IN RE: PETITION FOR ZONING VARIANCE
S/S Old Padonia Road 420'
W c/l of Broad Avenue
201 Old Padonia Road
8th Election District
3rd Councilmanic District
Wayne R. Gioioso, Jr.
Petitioner

* BEFORE THE
* ZONING COMMISSIONER
* OF BALTIMORE COUNTY
* Case No. 90-397-A
*

FINDINGS OF FACT AND CONCLUSIONS OF LAW

PRELIMINARY SITE PLAN

PETITIONER'S EXHIBIT 1

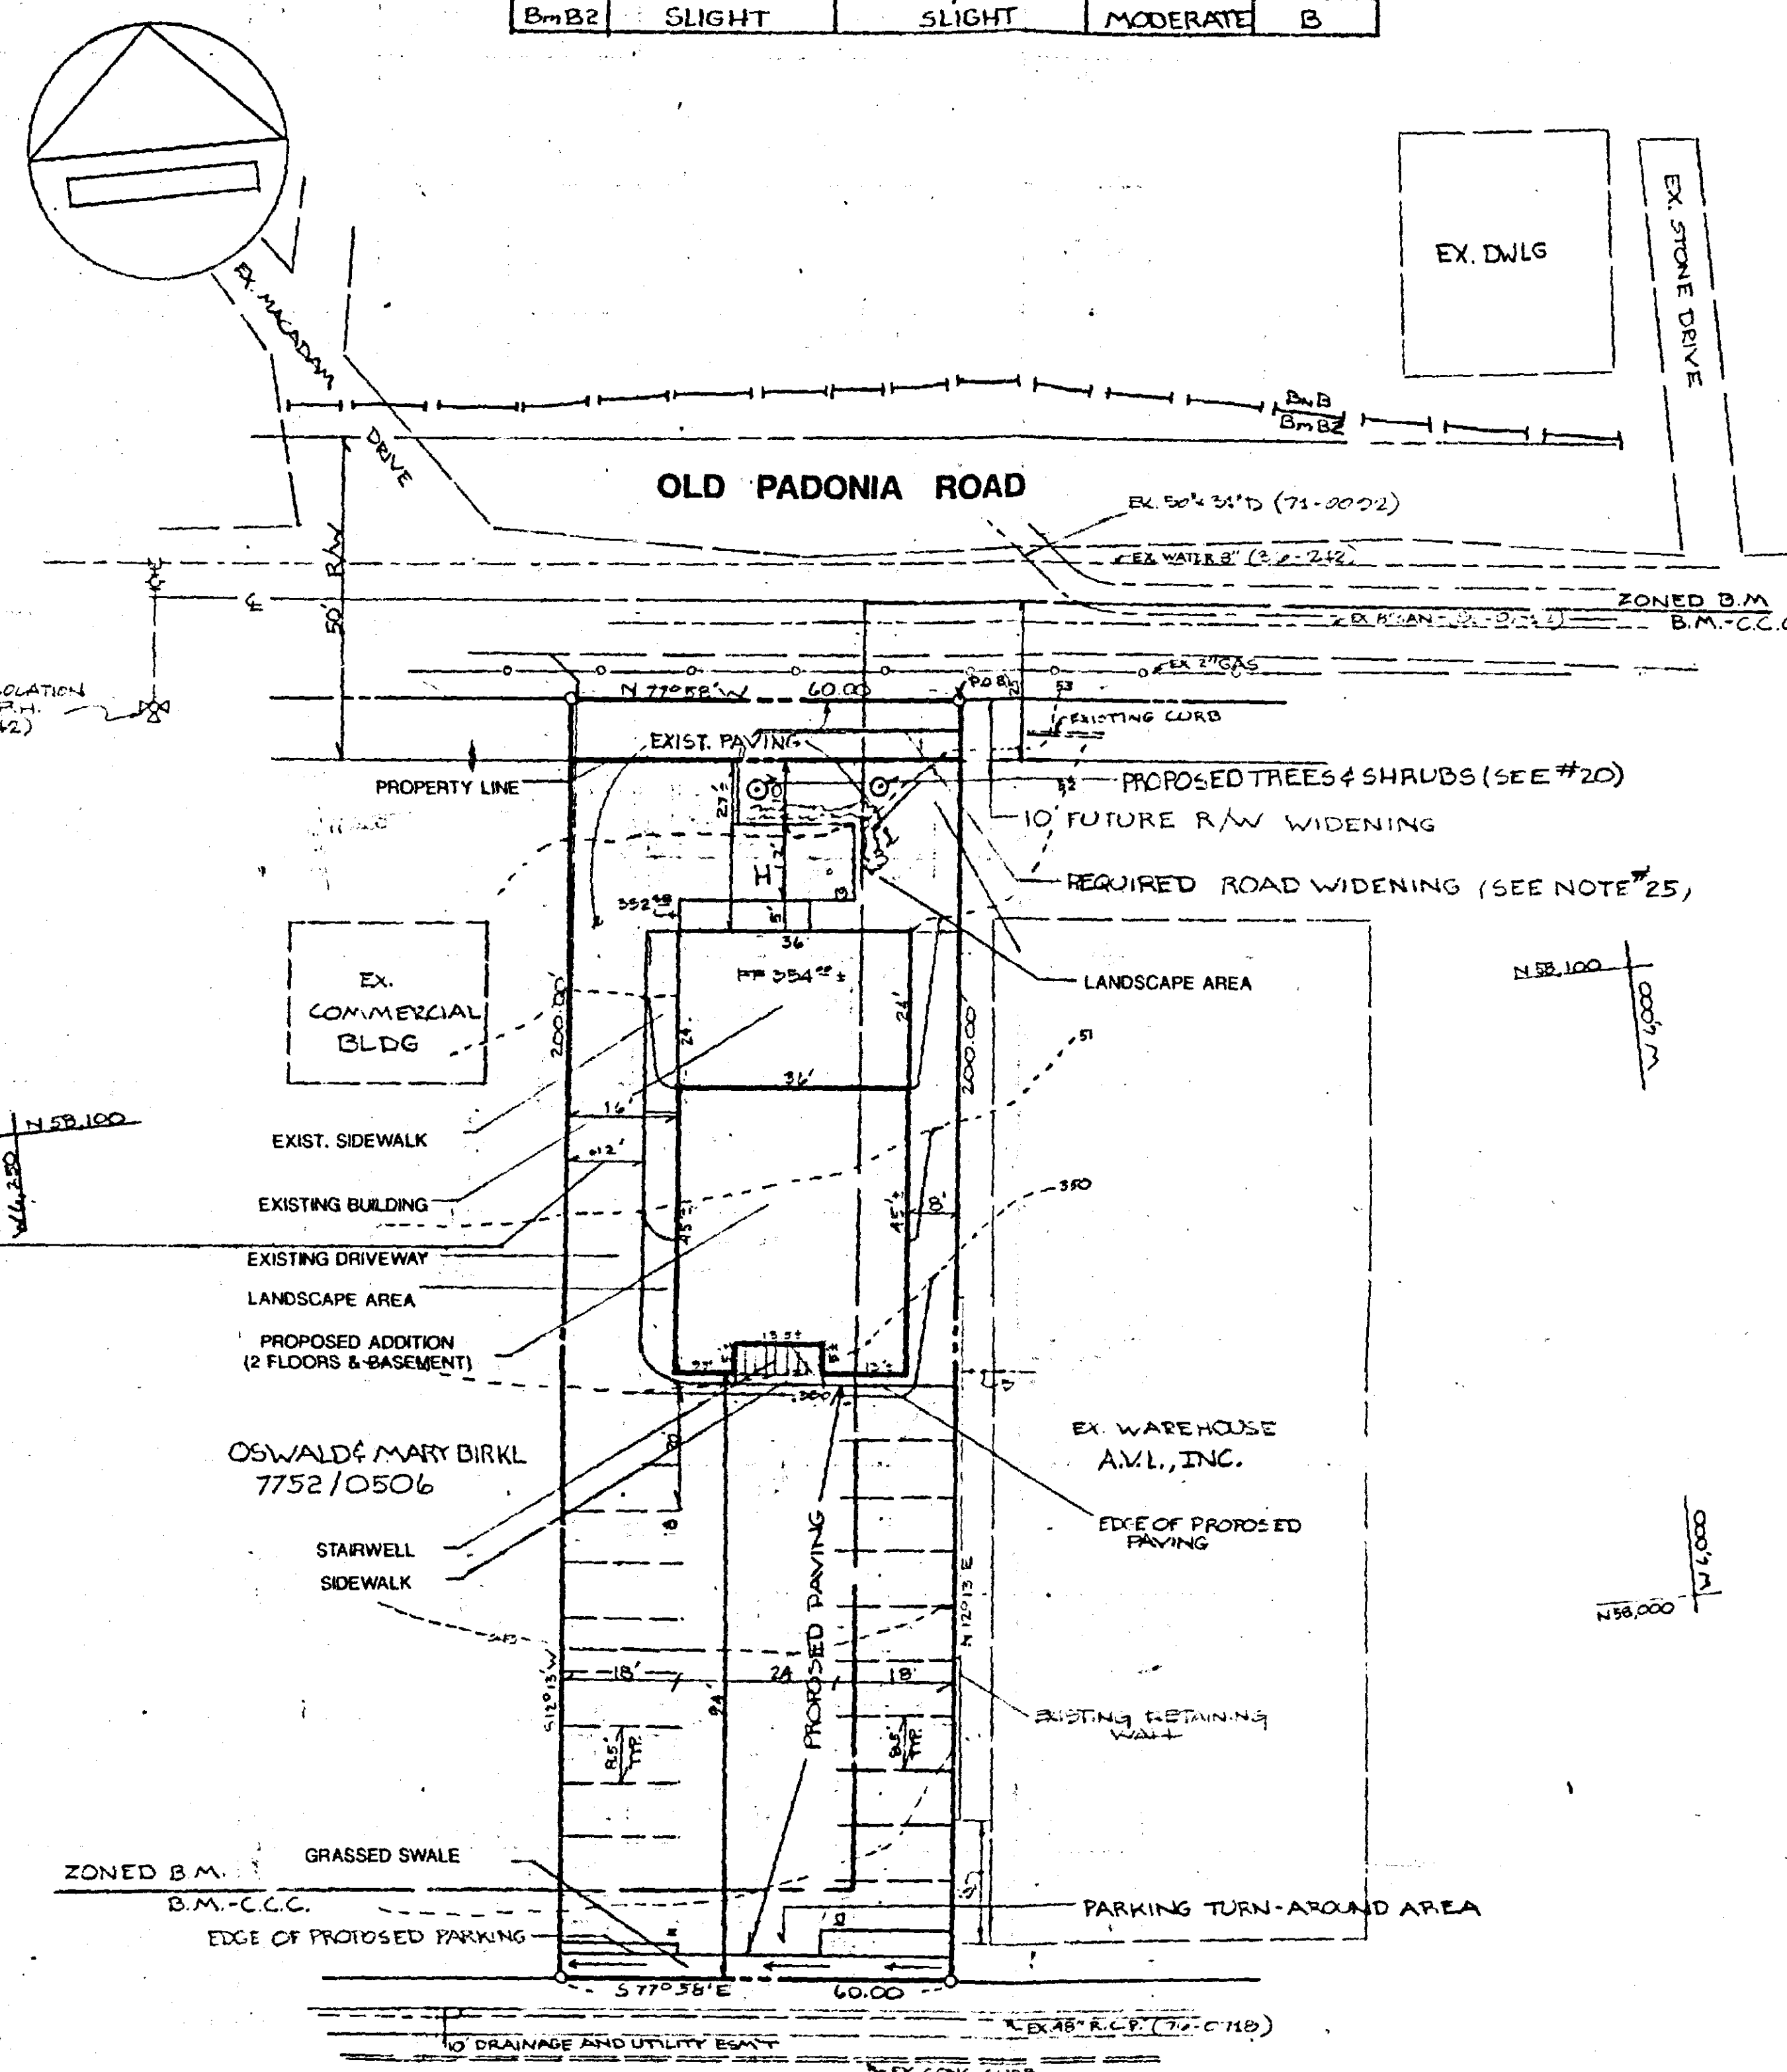
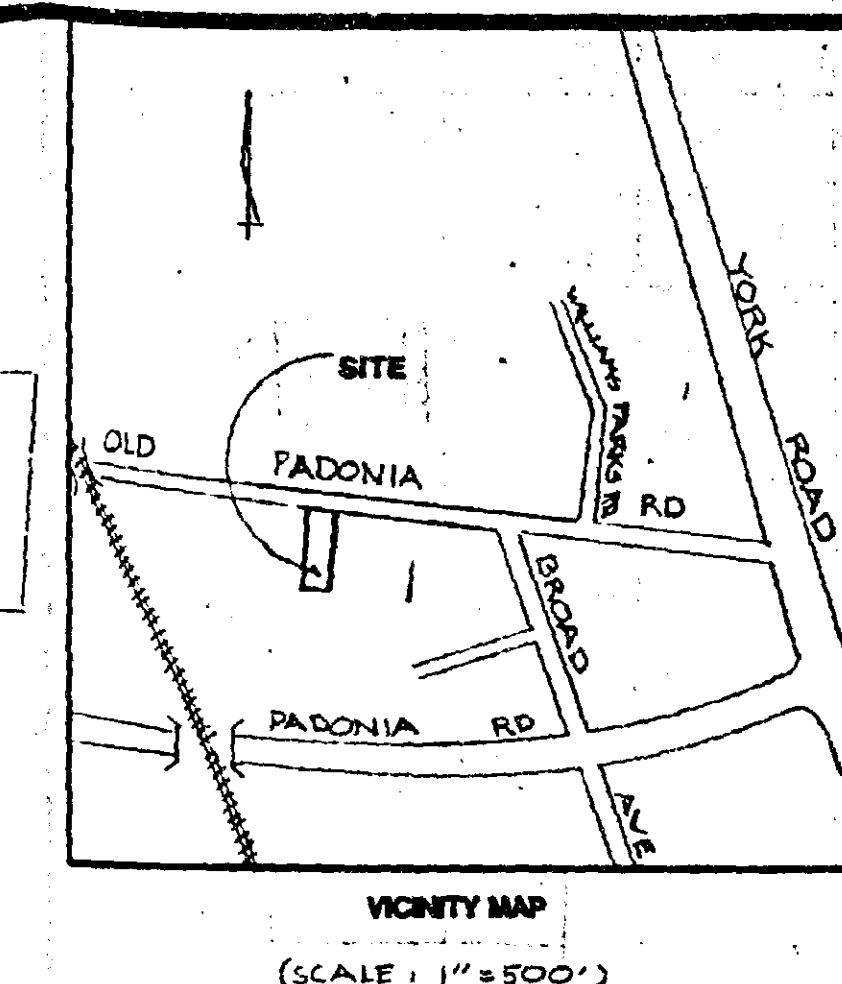
- The applicant applied for a waiver (W-89-174) of CRG meeting and a public works standard. The Planning Board granted a waiver of the CRG meeting and public works standard on July 20, 1989; however, the filing of a CRG plan was requested.
- The designated landscaped area is insufficient. The crushed stone area that exists on the east side of the building should be removed and replaced with a pervious area.
- Parking calculations should be revised to indicate required and proposed parking.

- Explore the possibility of entering into an agreement with the owner of the Birk property for a shared use in common driveway.
- The aforementioned crushed stone area should be removed and replaced with a pervious area.
- A landscape plan should be submitted to the Baltimore County landscape planner and the Deputy Director of the Office of Planning and Zoning prior to the issuance of any building permits.

Per your request, I met with Mr. Jeffrey Long of the Baltimore County Planning and Zoning Office regarding clarification of their staff comments. More specifically, we addressed the "insufficient landscaping" issue. Mr. Long informed me that their concern focused on a desire to have additional green area along the east side of the existing office building and the proposed addition. Upon more careful review of the site plan, which was submitted into the record at the time of the hearing, I was able to show Mr. Long that it was our intent to remove the driveway and macadam from this area and that in fact we would be providing for green space. Mr. Long indicated that the issue was resolved to his satisfaction.

PRELIMINARY SITE PLAN

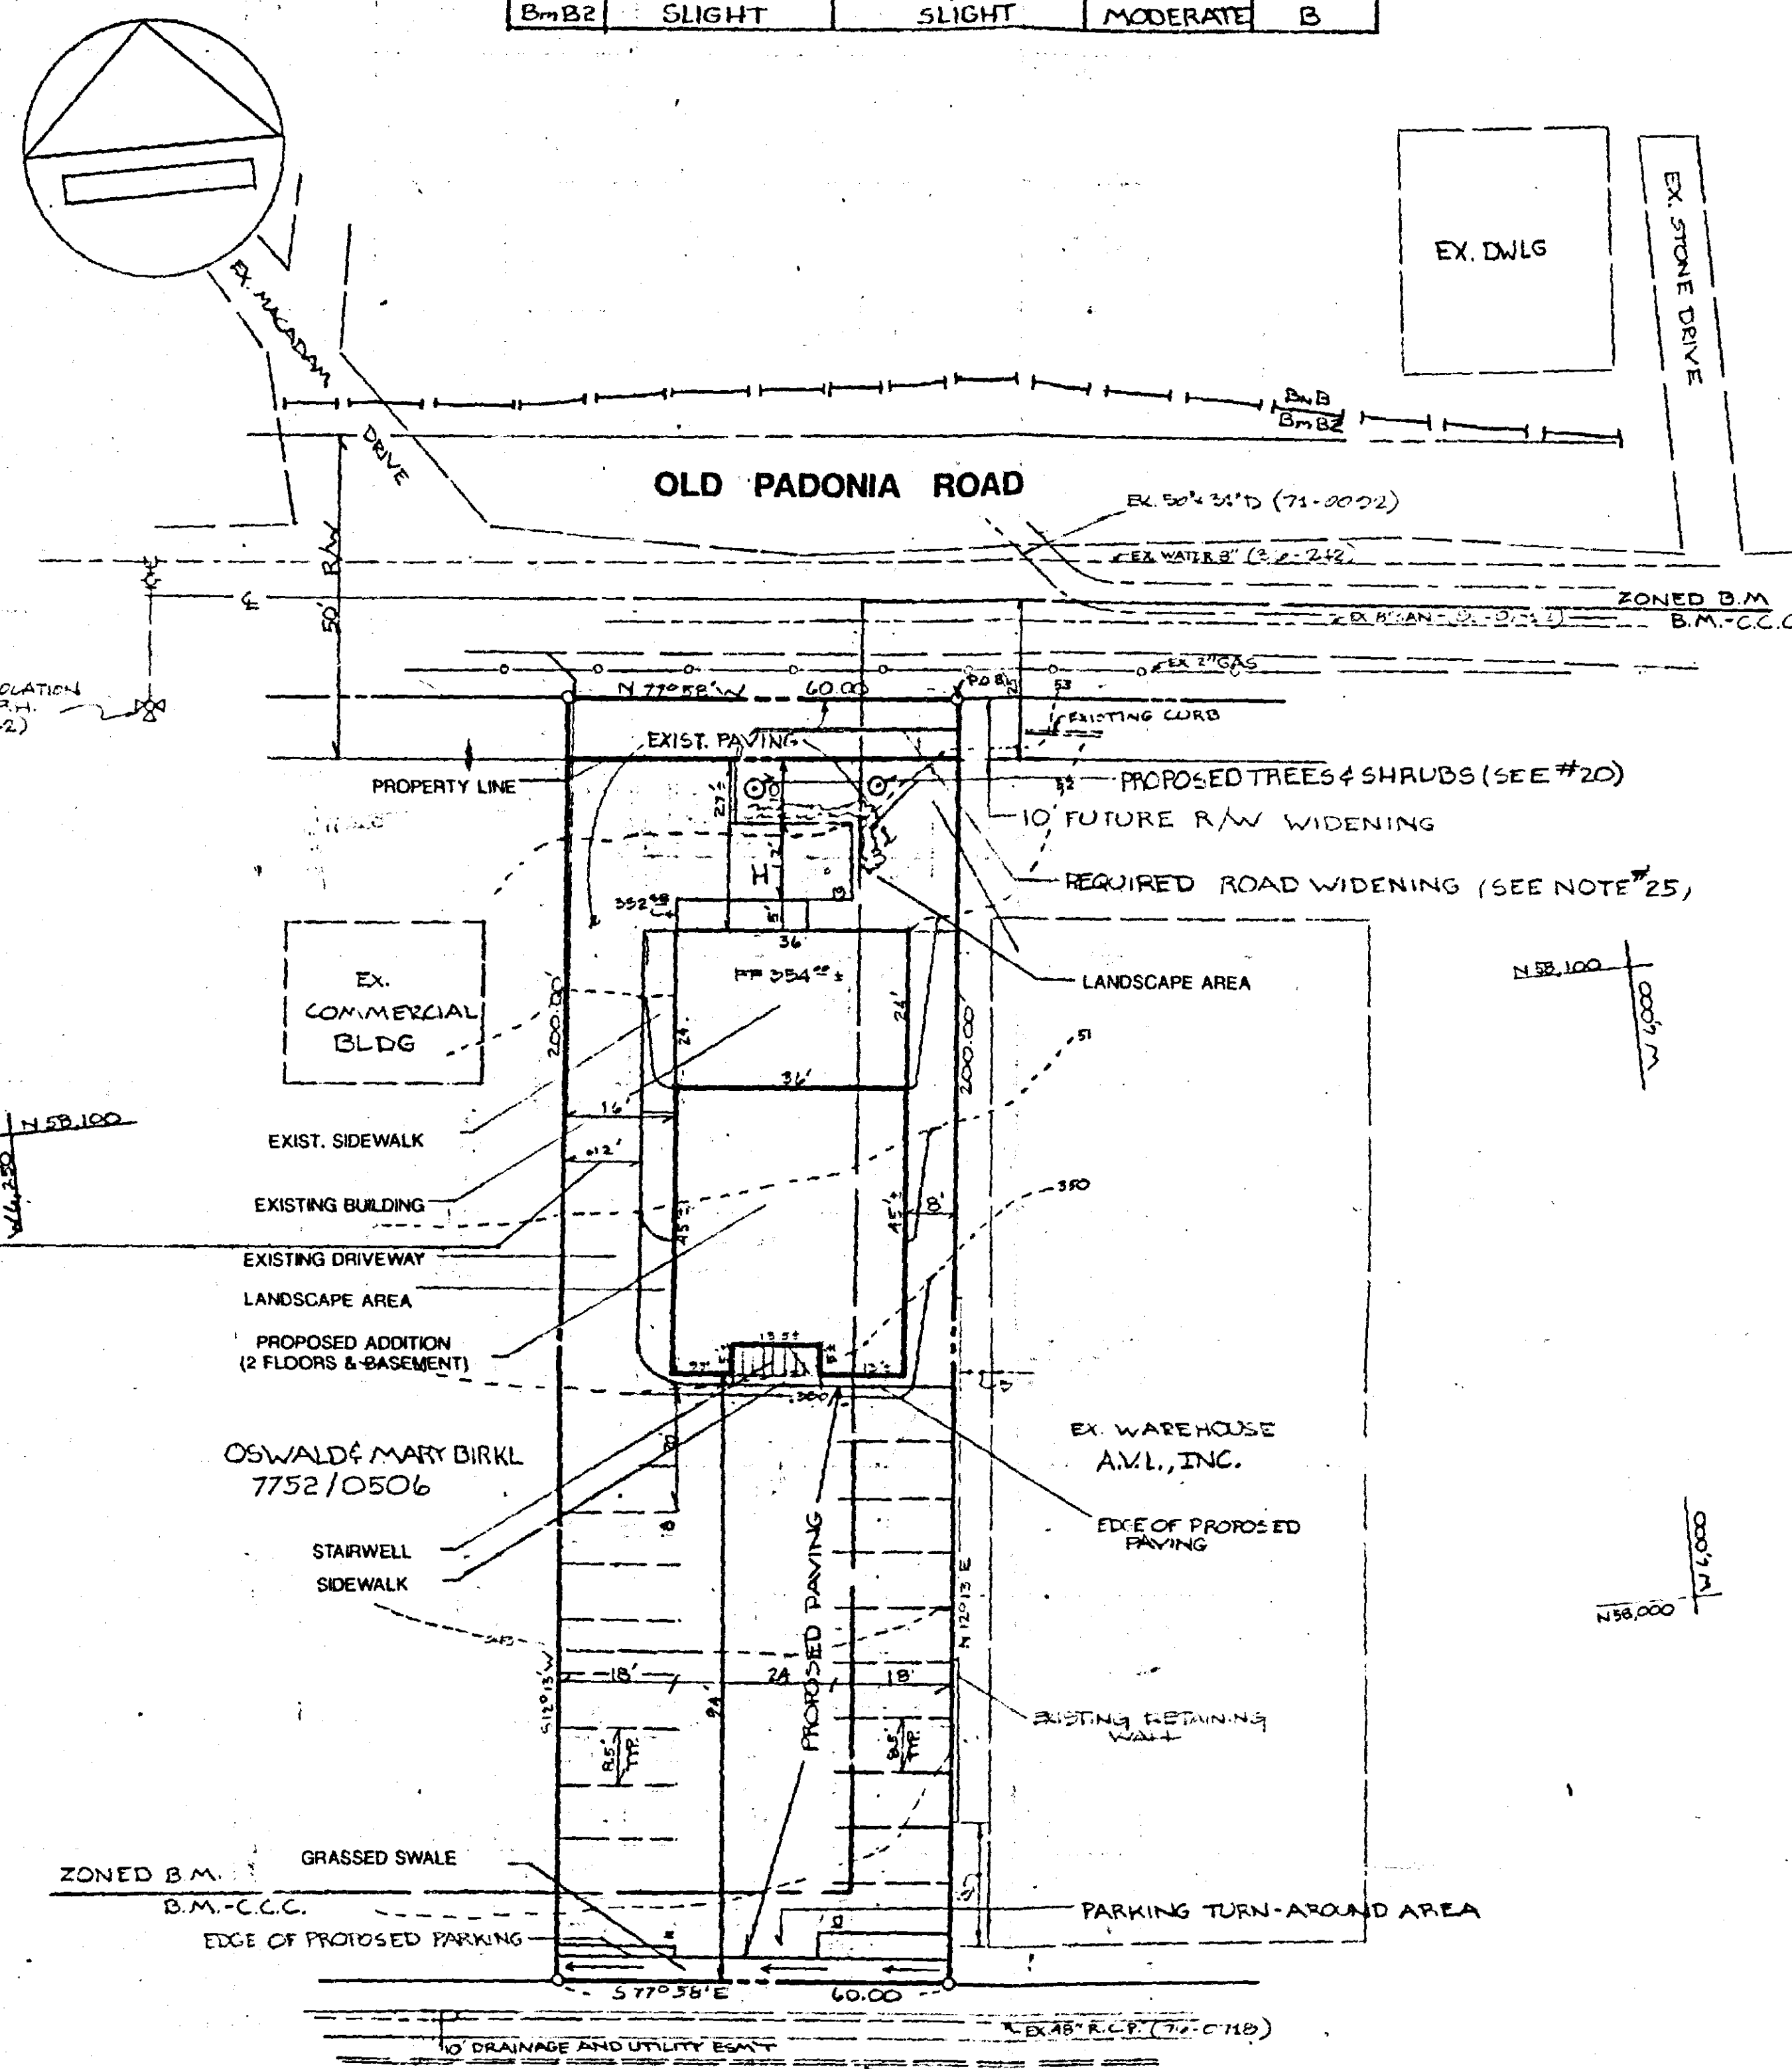
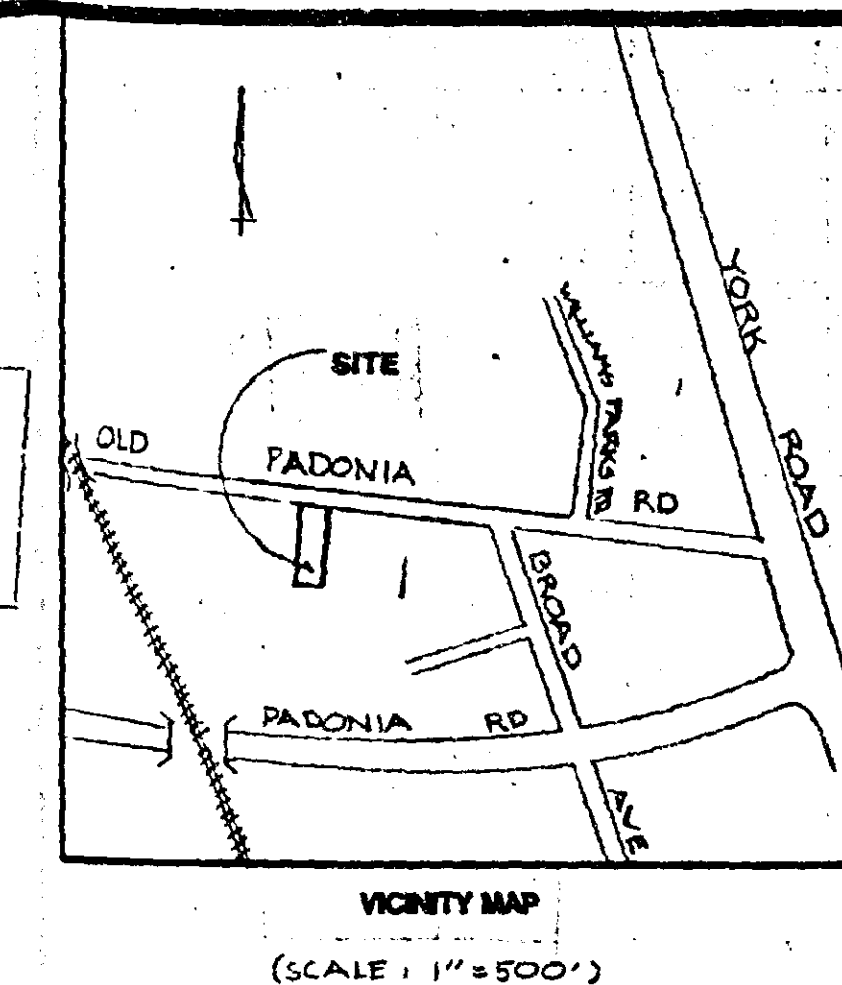
- The applicant applied for a waiver (W-89-174) of CRG meeting and a public works standard. The Planning Board granted a waiver of the CRG meeting and public works standard on July 20, 1989; however, the filing of a CRG plan was requested.
- The designated landscaped area is insufficient. The crushed stone area that exists on the east side of the building should be removed and replaced with a pervious area.
- Parking calculations should be revised to indicate required and proposed parking.

- Explore the possibility of entering into an agreement with the owner of the Birk property for a shared use in common driveway.
- The aforementioned crushed stone area should be removed and replaced with a pervious area.
- A landscape plan should be submitted to the Baltimore County landscape planner and the Deputy Director of the Office of Planning and Zoning prior to the issuance of any building permits.

Per your request, I met with Mr. Jeffrey Long of the Baltimore County Planning and Zoning Office regarding clarification of their staff comments. More specifically, we addressed the "insufficient landscaping" issue. Mr. Long informed me that their concern focused on a desire to have additional green area along the east side of the existing office building and the proposed addition. Upon more careful review of the site plan, which was submitted into the record at the time of the hearing, I was able to show Mr. Long that it was our intent to remove the driveway and macadam from this area and that in fact we would be providing for green space. Mr. Long indicated that the issue was resolved to his satisfaction.
